Canadian Nuclear Laboratories (CNL)

Application from the CNL to amend its Chalk River Laboratories site licence to authorize the construction of a near surface disposal facility

**Two Evaluations of CNL's Proposed Radioactive Waste Disposal Facility
By W. Turner (AECL Retiree and Resident of Deep River)**

Figure 5: Cross-Section of CNL's Mound [14]

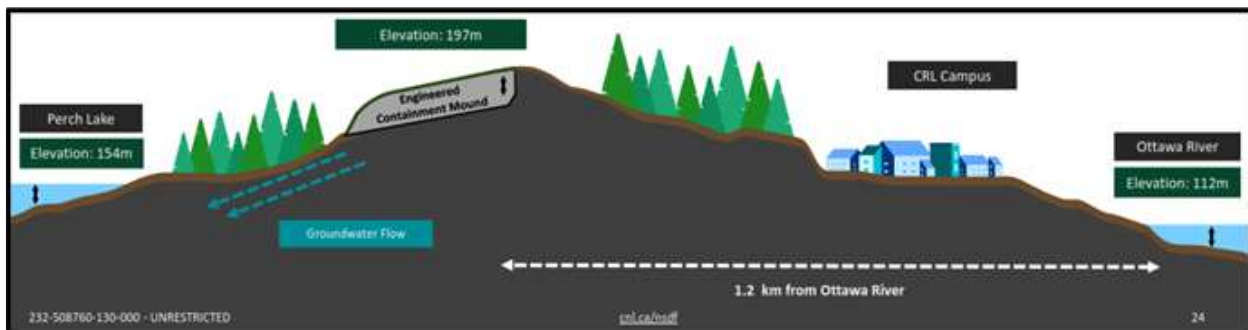
Consider Figure 5, copied from CNL's slide deck for the Part One hearing [14]. It depicts the cross-section and the hillside location of CNL's proposed mound. While it is unlikely to be to scale (given the height of the trees), it is indicative of these issues with CNL's Site Selection process. As one can see, there is no "...evidence of natural containment and isolation...".

As shown, CNL's proposed facility is located on the side of hill which means providing much in the way of natural containment is unlikely. Then there is the additional issue that CNL actually reduced any existing natural containment capabilities by relaxing the slope restriction from 10% to 25% (see Section 2.1.1 above).

As to whether this location provides any natural isolation capabilities, that too is doubtful. Since Figure 5 depicts trees at the bottom of the hill, this figure is deliberately deceptive. We know from all other depictions of their mound, at this location, the mound is surrounded by wetlands, not trees. As shown in Figure 6, those wetlands are in fact about 30 metres from the fence line at the bottom of the hill. Thirty metres does not provide much in the way of natural isolation.

Figure 5 confirms the fact that CNL's site selection criteria did not address any natural containment and isolation features that could address the safe disposal of radioactive wastes in their proposed mound

Figure 6: Facility Site Layout as Depicted in the CMD22-H7 Figures 2 and 10 [1]

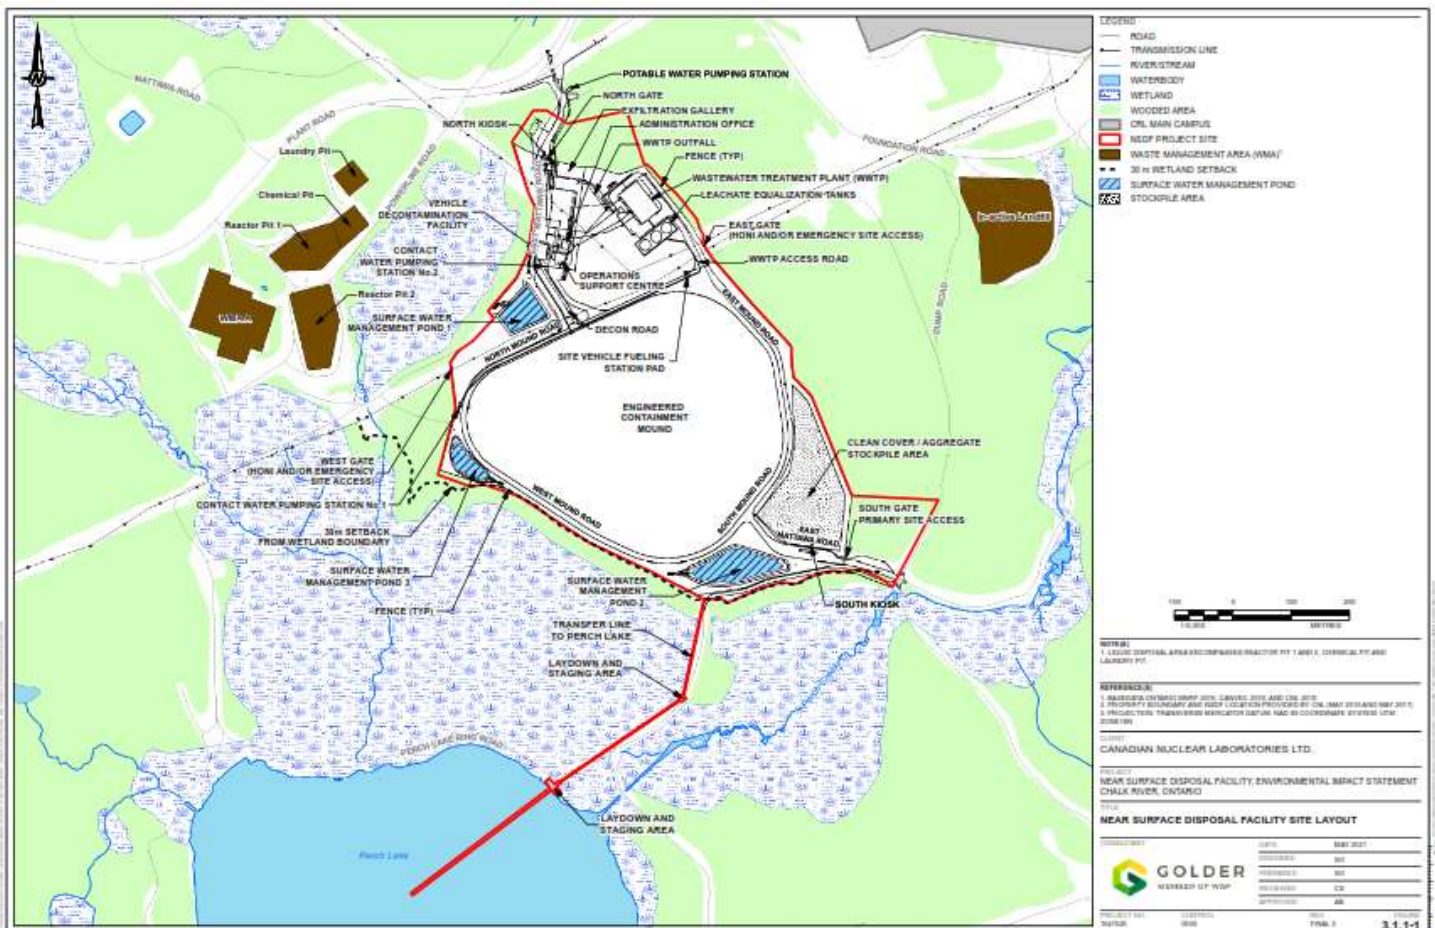
Consider Figure 6, copied from their 2021 EIS report. As depicted in this figure, this road provides both the entrance and the exit (that is, the north and south gates) to CNL's proposed mound facility. Since there is no other road depicted (such as the “new” ER3, which according to their 2017 EIS report [13], were planned at least five years ago, see Section 3.2.1 above), it is safe to assume that the road identified as the “East Mound Road” is the ER3 road. If so, it circles the east side of the facility within the boundaries of the mound facility site as shown in this figure.

As depicted in Figure 6, the East Mattawa Road provides both the entrance and an exit to the mound. Thus, this road is incidental to the “designated project” and must be included in the environmental assessment for CNL's proposed disposal project. Yet, neither CNL's latest EIS report [12] nor the CNSC's EA summary report [1] include any consideration of the environmental effects related to the location of the East Mattawa Road, and the re-routing of ER3.

However, as depicted in Figure 6, the re-routing of ER3 has yet to occur. As of this writing, the straddling the ER3, the location of CNL’s proposed mound will seriously impacts the SCA for the site.

Figure 4: A Depiction of CNL's Safety Assessment Scenarios

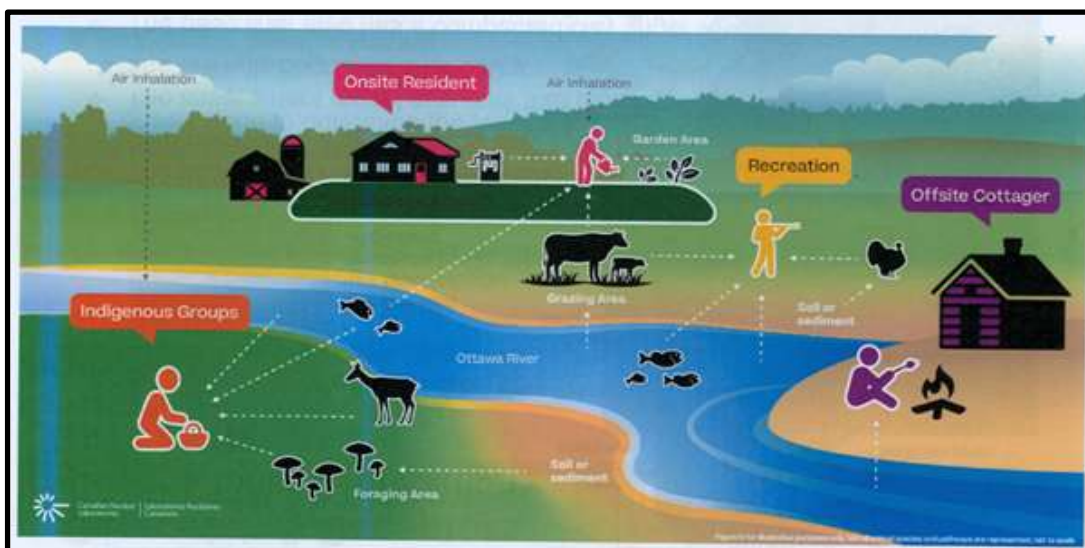
Figure 4 depicts the scenarios assessed in CNL's safety analysis. Figure 5 provides some additional pathways from the source to the receptors depicted in Figure 4.

Aside from the fact that the assumption that one can predict the lifestyle of any future resident, indigenous group or cottager 100 years into the future is unreasonable, we can identify issues with the pathways as depicted in Figure 4.

For example, CNL's mound is missing. That said, the only receptor directly impacted is the resident. Given that the mound is located more than 1 km from the Ottawa River, all other receptors are considerably further away from CNL's proposed disposal facility. Thus, the pathway from the source (i.e. the mound) to these receptors will result in a

Figure 6: Project Timeline - Copied from Reference [17]

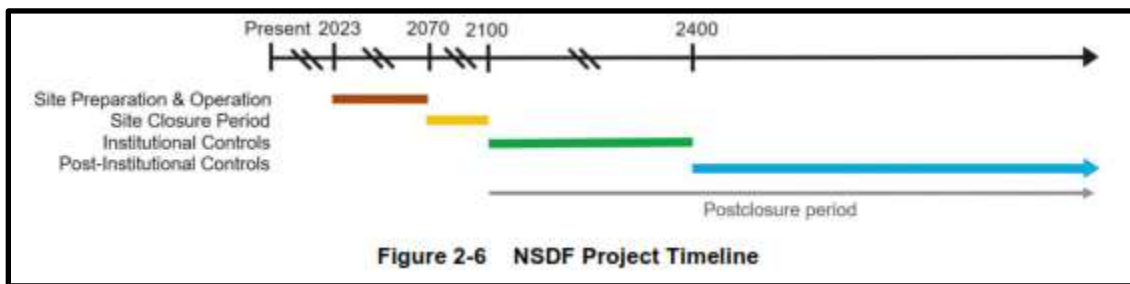
One answer to this question is that, by depicting the “Post-Institutional Controls” as a blue arrow in Figure 6, these restrictions will be required in perpetuity since, as discussed in Sections 2.4 and 4.4 above, the non-radiological constituents remain hazardous forever.

Therefore, both CNL and the CNSC need to provide a description of the facility at the end of the 300 years. That description needs to address any postulated receptors and identify any remaining hazards. Since the quantity and nature of those non-radiological hazards are currently based on guesstimates (see Section 2.3.1 above), these cannot be used to assess the potential consequences to the biosphere after the 300 years.

Figure 7: Project Timeline - Copied from Slide 24, CNSC Webinar, October 20, 2021 [30]

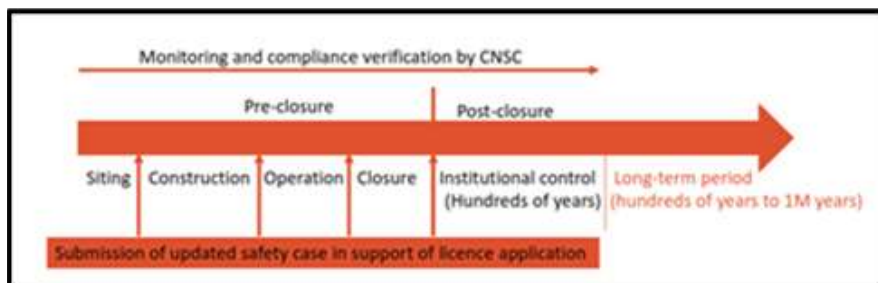
However, nowhere in any documentation reviewed does AECL, CNL, and the CNSC define "...as long as necessary..." Nevertheless, Figure 7 [30] does provide an indication of what the CNSC may indicate their definition for "... as long as necessary...", which is 300 years (see Figure 6 and Figure 7).

NOTE: Both Figure 6 and Figure 7 assume that over the 300-year IC period depicted, there will be

Given that the current owner has a history of about 75 years, and the current regulator has a history of a little over 20 years, this assumption is tenuous at best.
